Motor Business Unit,
Electromechanical Control Business Division,
Automotive & Industrial Systems Company,
Panasonic Corporation

Software Version Upgrade Notice
for AC Servo Driver of MINAS A6SE, A6SG and A6SF series

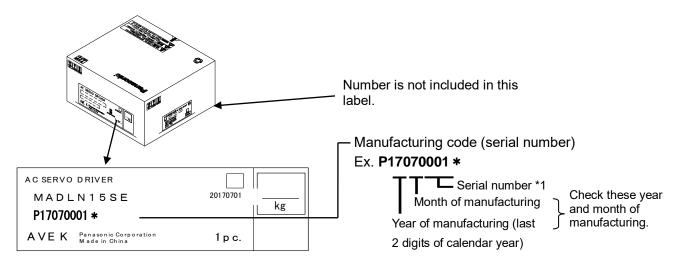
• Method involving checking the software version

The software version can be checked by using the setup support software (PANAERM), or by checking from the RTEX communication command.
